**From:** Justin, Michael A.  
**Sent:** Tuesday, December 13, 2011 9:24 AM  
**To:** 'John Graves'; Hunker, Brian M.  
**Cc:** Nelson, Lydia C.; Mike Hennes  
**Subject:** FW: CGF- Info\_ SHPO Ref: 10-0173

## **TECHNICAL MEMO**

**RE:** Recent Revisions to Geomorphological Model for Locating Areas with Potential for Deeply Buried Archaeological Deposits Along the Center to Grand Forks 345 kV Transmission Line Corridor in North Dakota.

Area 1 Stream Crossing 2 (Gray = Low Potential)

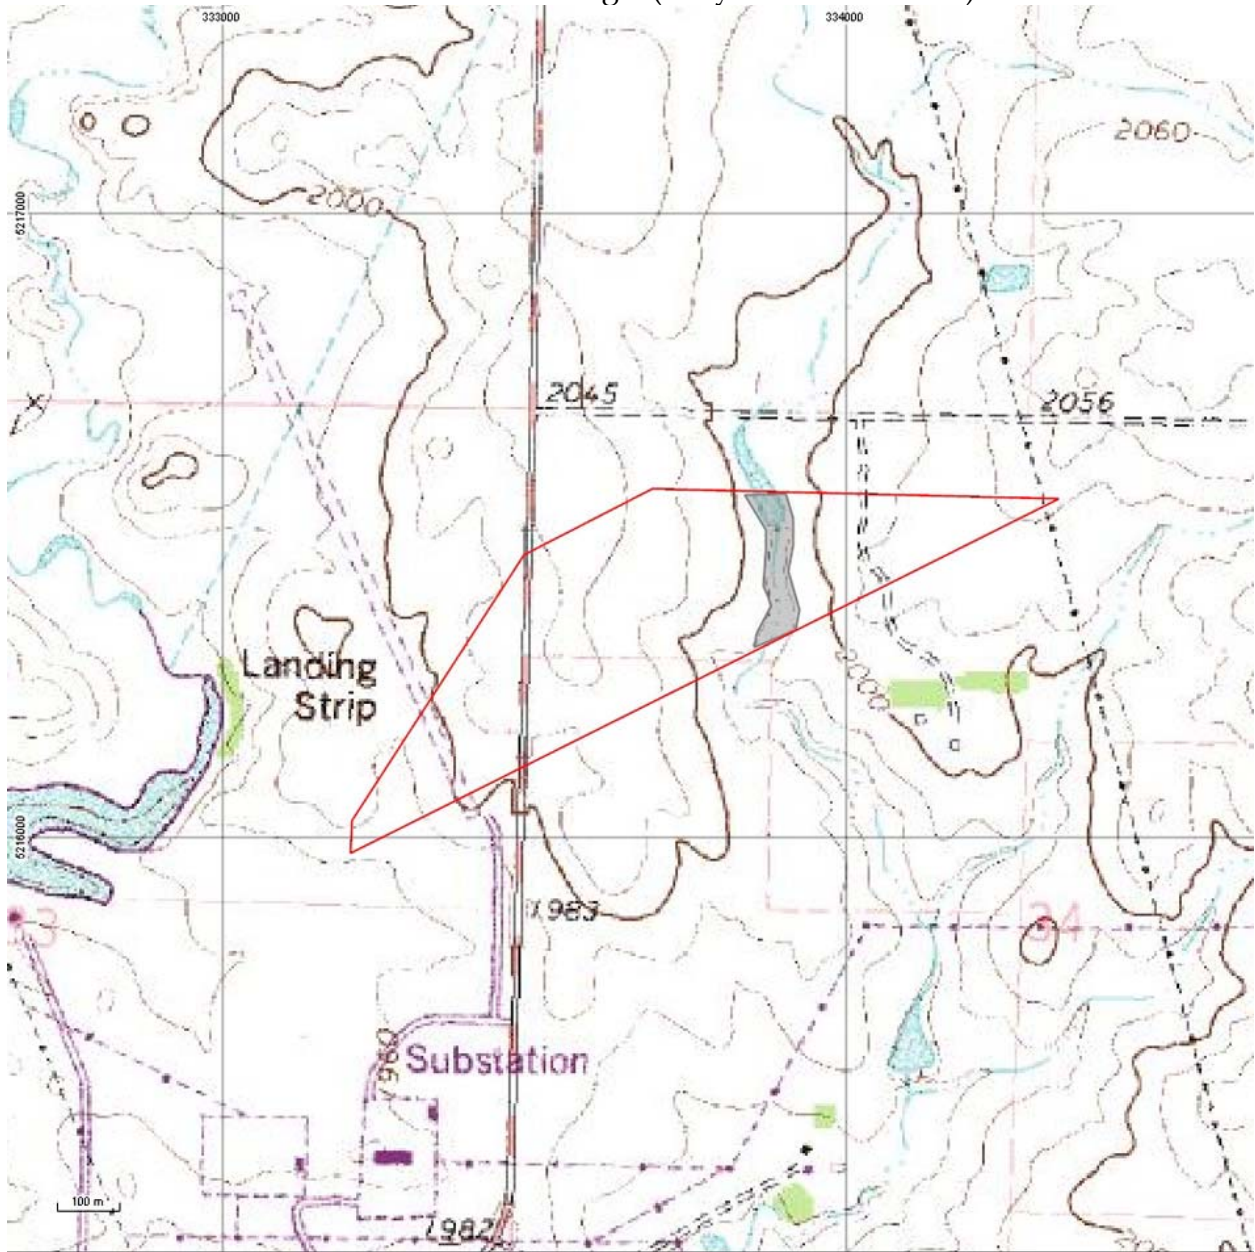
Thank you for forwarding the memo and accompanying maps. We concur with the assessment of geomorphic potential for near-surface and buried deposits in those locations indicated, including revisions to the proposed route.
